**GE Energy
Nuclear**

NEDO-33330
Class I
eDRF 0000-0067-1515
May 2007

LICENSING TOPICAL REPORT

**Advanced Boiling Water Reactor (ABWR)
Hydrogen Recombiner Requirements Elimination**

FIGURE 5.4-10 RESIDUAL HEAT REMOVAL SYSTEM P&ID (Sheet 4 of 7)
ABWR DCD/Tier 2 Rev. 0 21-106

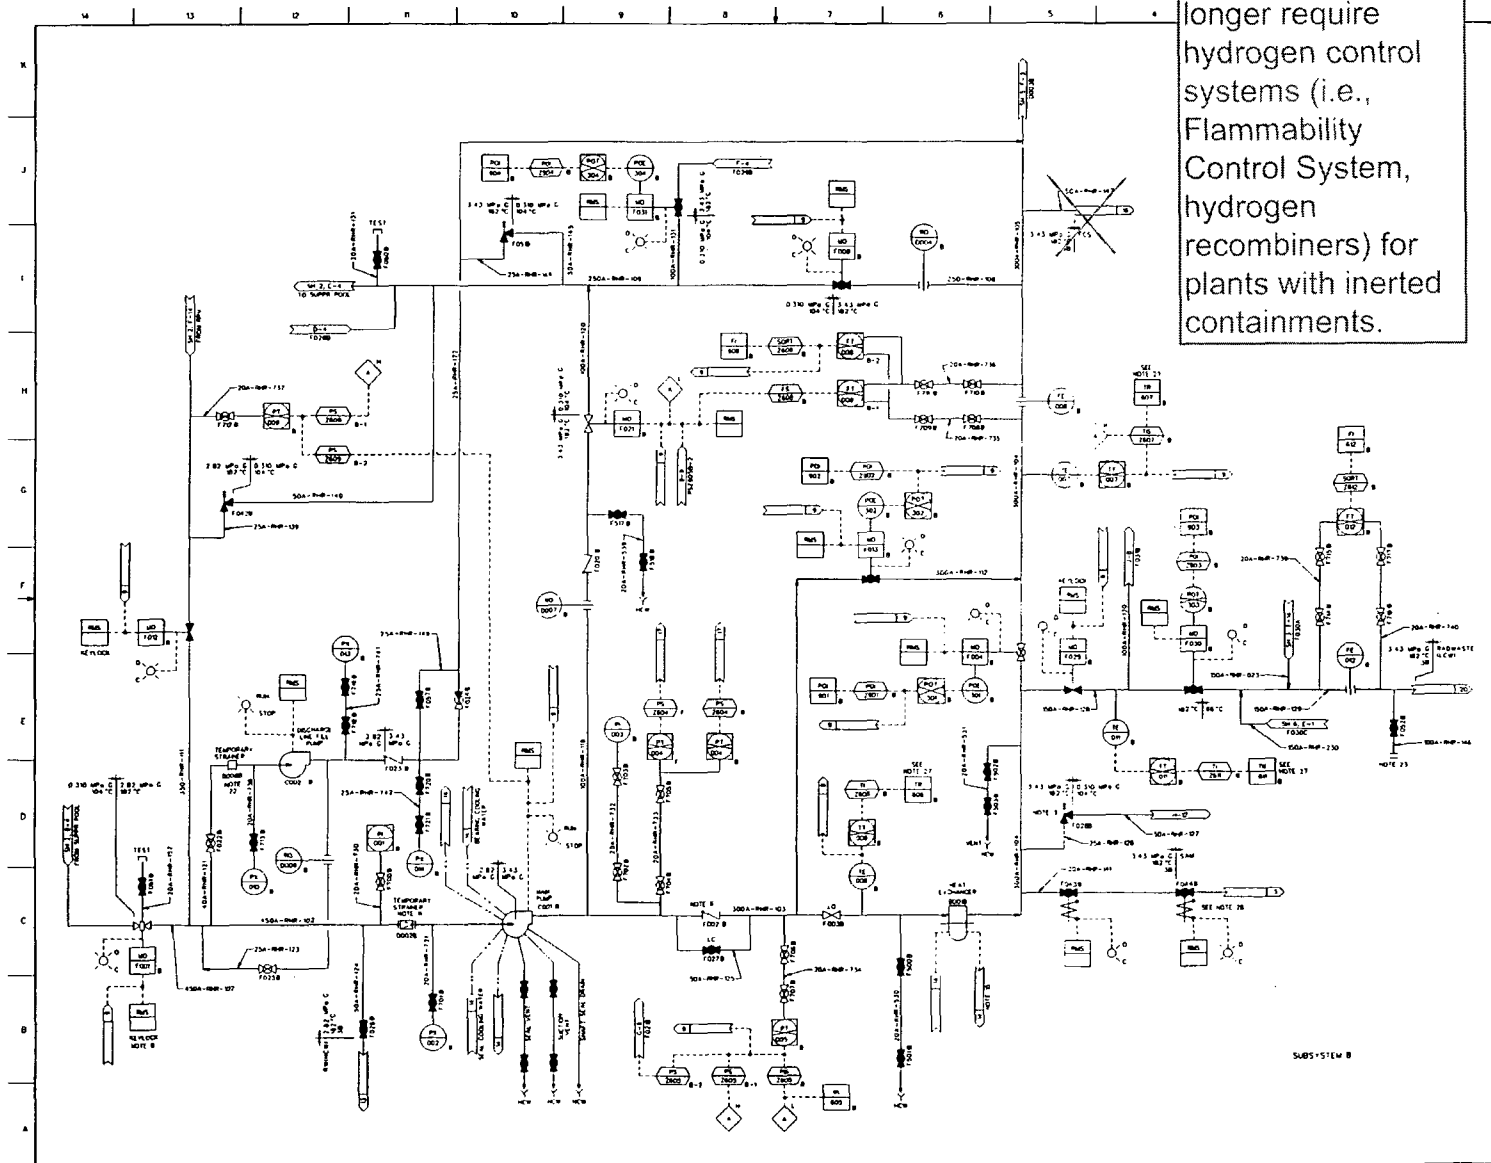
10CFR50.44 was revised on October 16, 2003 to no longer require hydrogen control systems (i.e., Flammability Control System, hydrogen recombiners) for plants with inerted containments.

10CFR50.44 was revised on October 16, 2003 to no longer require hydrogen control systems (i.e., Flammability Control System, hydrogen recombiners) for plants with inerted containments.

FIGURE 5.4-10 RESIDUAL HEAT REMOVAL SYSTEM P&ID (Sheet 6 of 7)
 ABWR DCD/Tier 2 Rev. 0 21-108

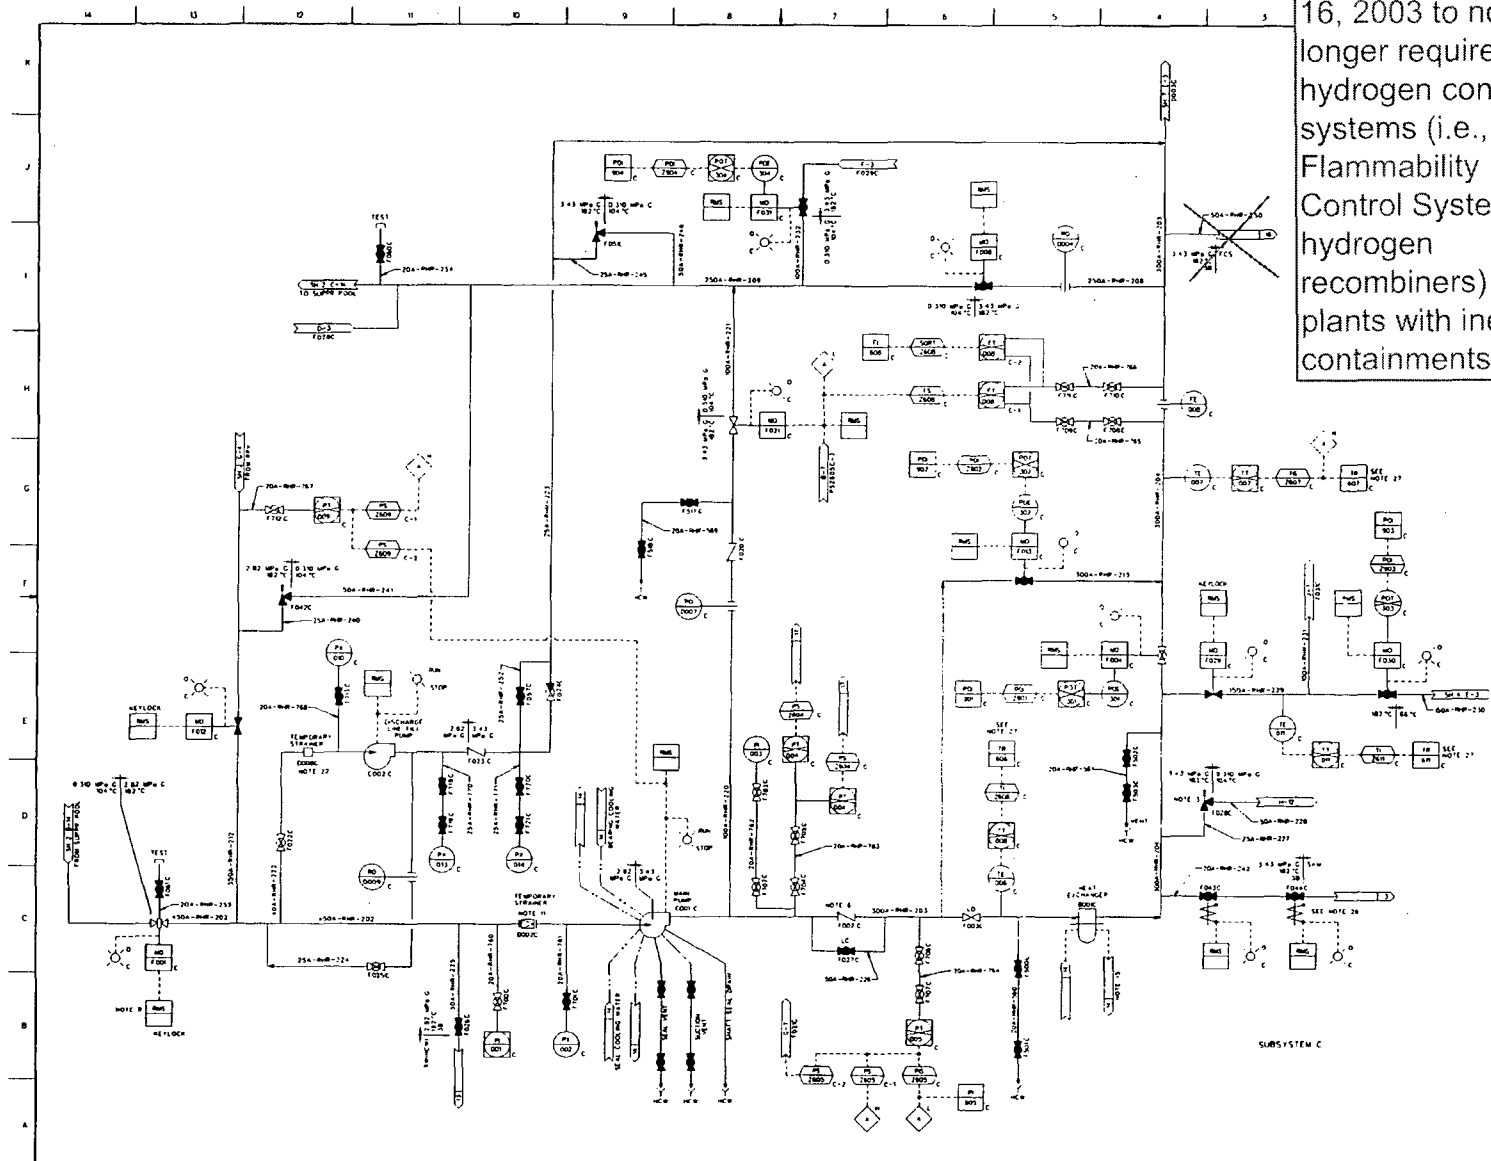
10CFR50.44 was revised on October 16, 2003 to no longer require hydrogen control systems (i.e., Flammability Control System, hydrogen recombiners) for plants with inerted containments.

FIGURE 6.2-40. FLAMMABILITY CONTROL SYSTEM P&ID (Sheet 1 of 21)
ABWR DCD/Tier 2 Rev. 0 21-123

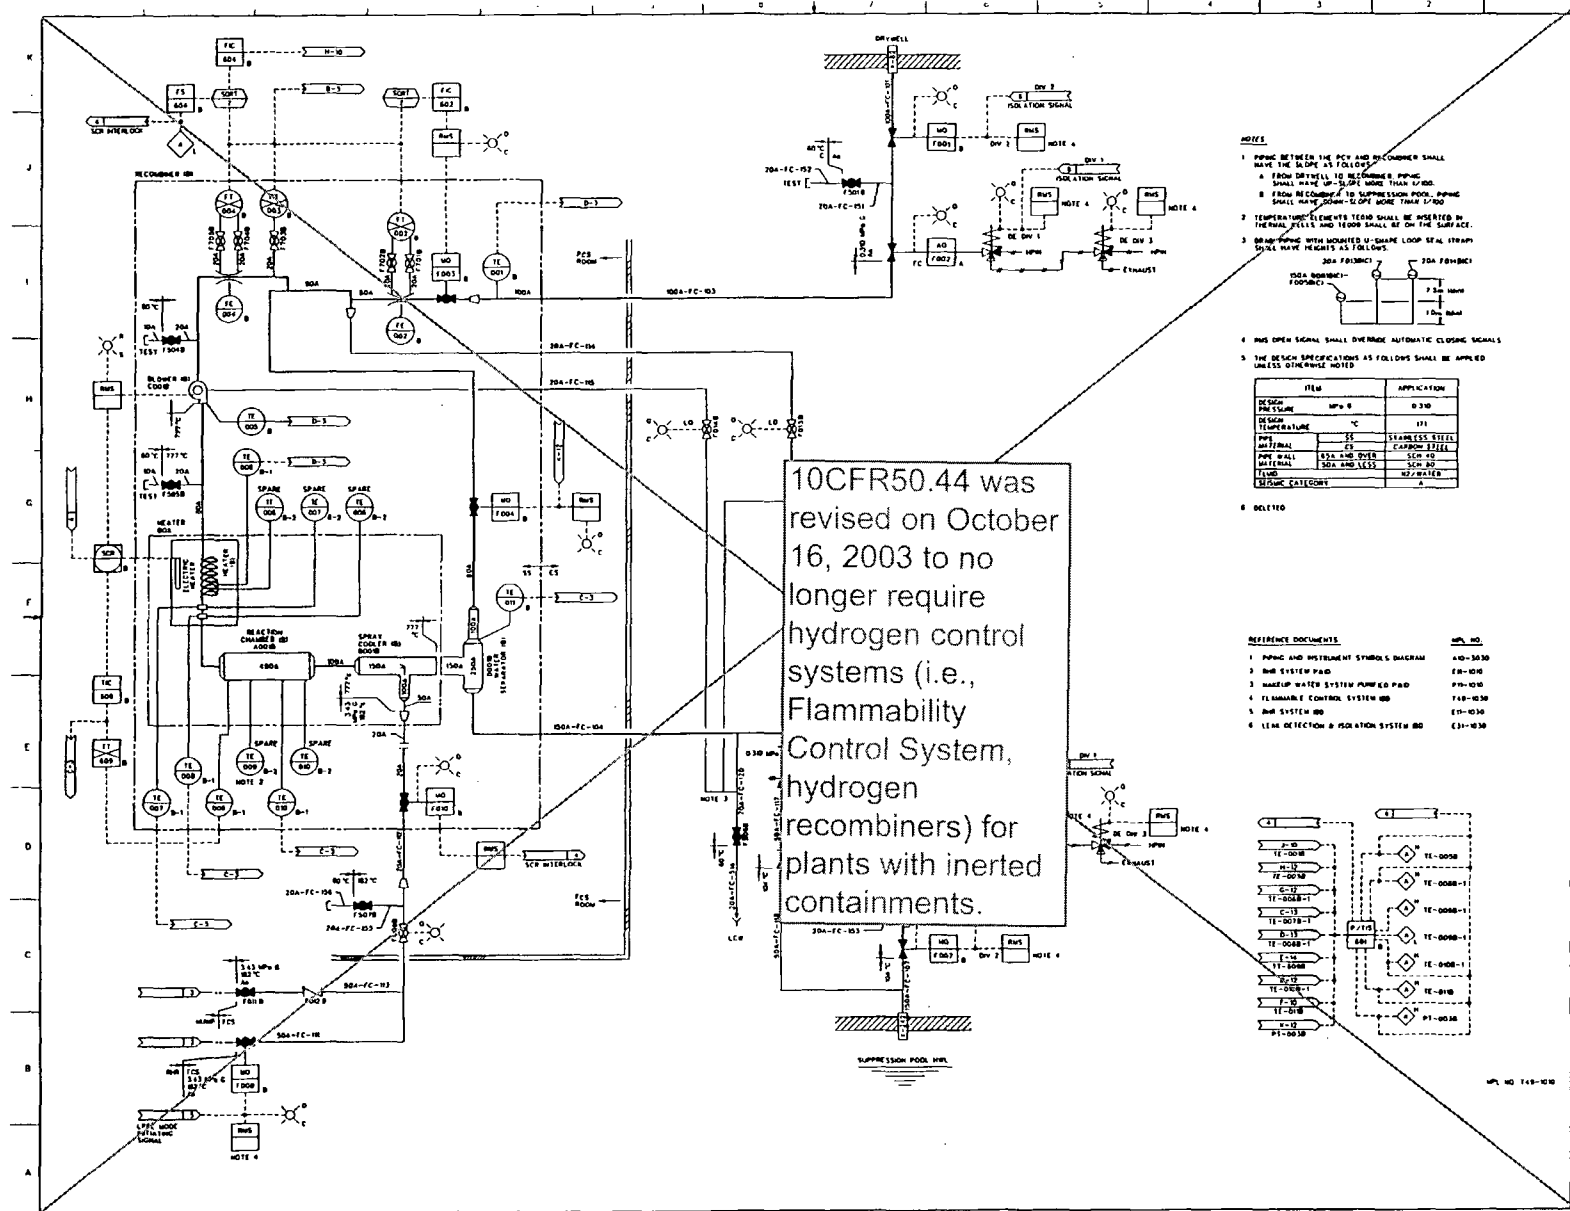
The changes described in this LTR are to Tier 1 and Tier 2 of the ABWR DCD Revision 4. This includes the piping and instrumentation diagram (Figure 6.2-40) changes that are marked in Appendix C.

10CFR50.44 was revised on October 16, 2003 to no longer require hydrogen control systems (i.e., Flammability Control System, hydrogen recombiners) for plants with inerted containments.

Figure 15A-7 Safety System Auxiliaries — Group 2

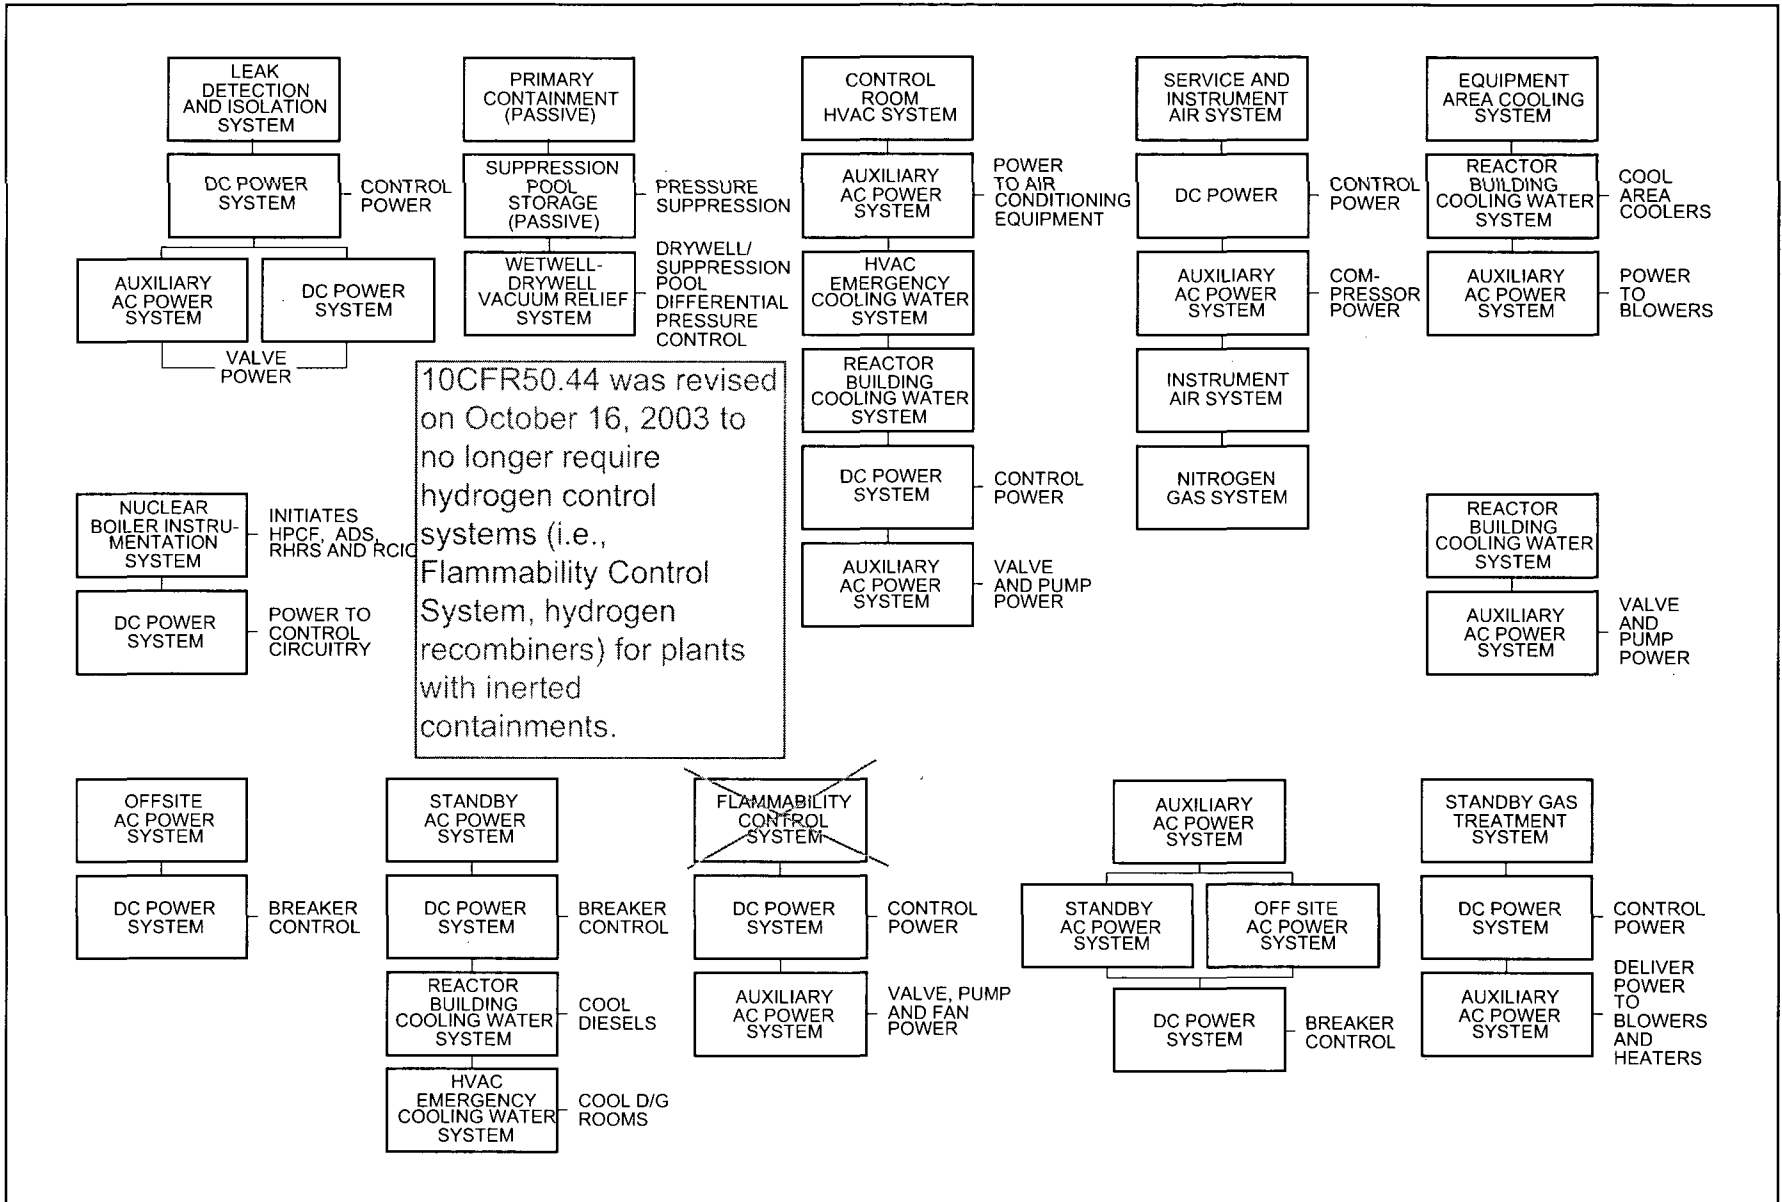
10CFR50.44 was revised on October 16, 2003 to no longer require hydrogen control systems (i.e., Flammability Control System, hydrogen recombiners) for plants with inerted containments.
